850 Sligo Avenue Sketch Plan No. 320180090

Completed: 03/23/2018

SECTION 1: RECOMMENDATIONS AND CONDITIONS

Figure 4: Section of Applicant's proposal demonstrating the allowable building height.

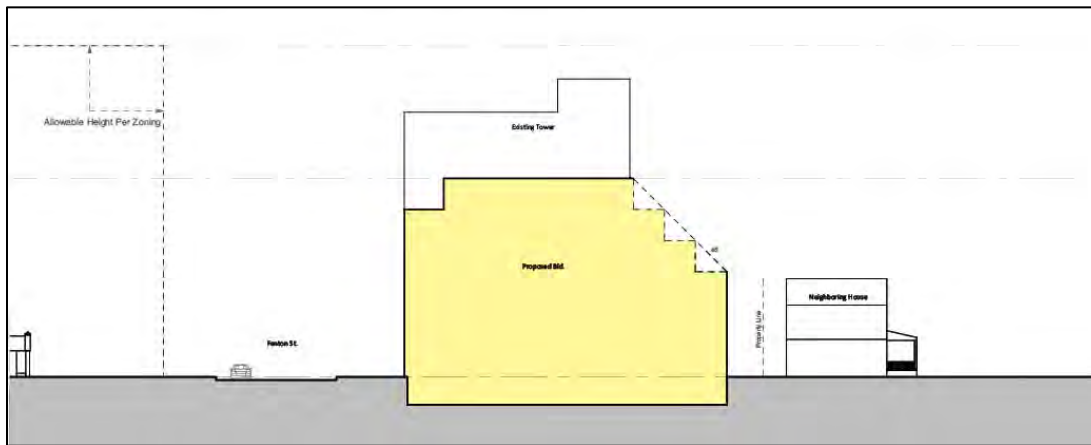
In accordance of Section 4.1.8.B.2.a of the Zoning Ordinance the building must match the height limit at the eastern edge of the property adjacent to the single-family homes and then is allowed to increase its height 1 foot for every foot it steps back. Staff recommends that the Applicant does not maximize the height at 35 feet at this edge but should set the height of the building to the actual height of the single-family homes.

Figure 4 shows the allowable building heights and step backs about the existing single-family houses. The Applicant will need to work with the homeowners to provide an acceptable solution to the building massing by providing a two to three story base that steps back to minimize the perceived building mass.

Figure 5: View of Applicant's proposal along Gist Avenue looking west toward Fenton Street

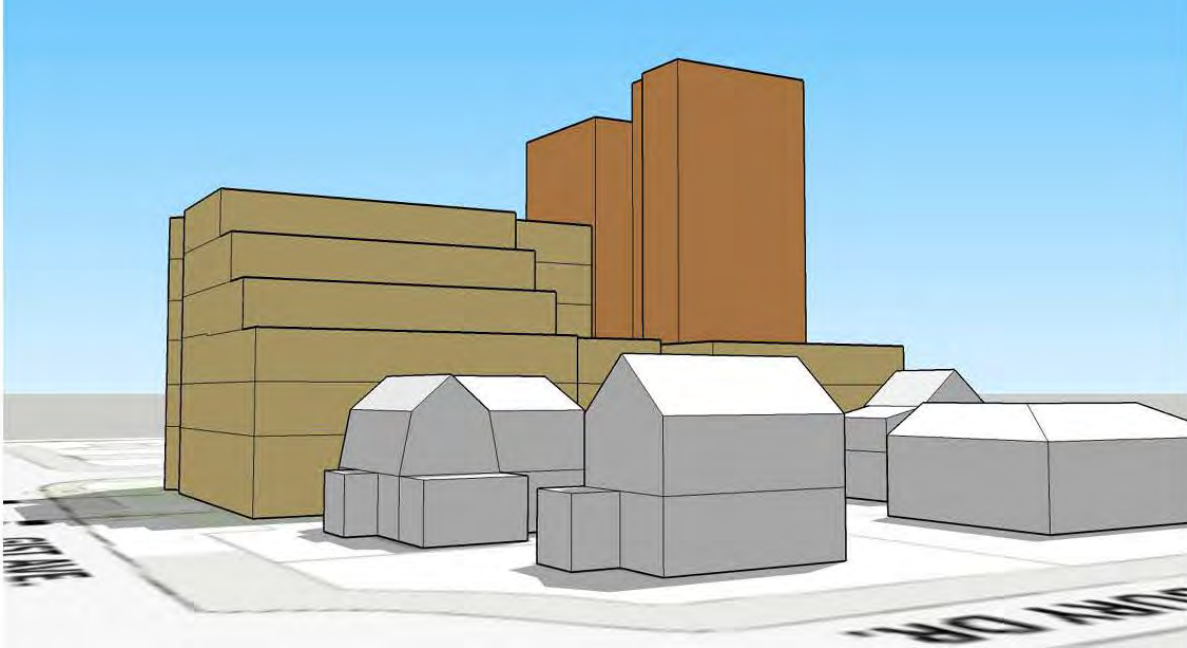
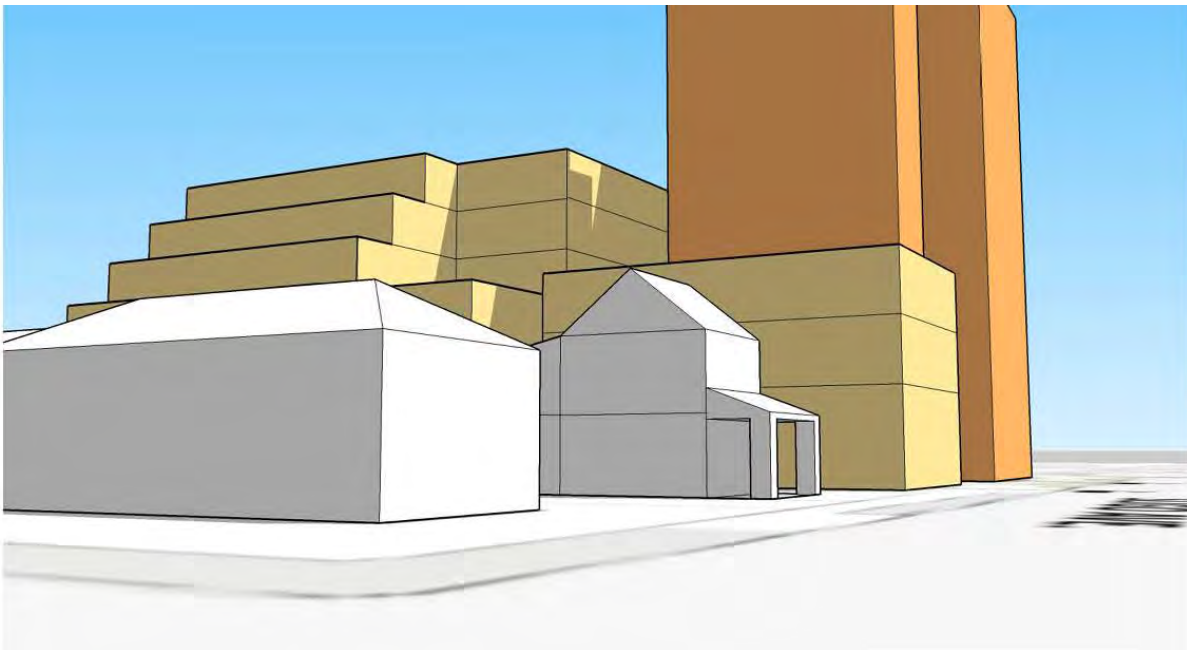
This project presents an opportunity to improve the relationship between the CBD and lower density residential through the careful use of massing, and façade articulation of the buildings. It may be possible to set a portion of the building along Sligo and Gist avenues further back than the build-to line to form a better relationship with the existing single-family homes. The massing could also step down lower at the edge of the property line to be lower

than the allowable 35 feet height to improve the relationship between the building and the existing single-family homes.
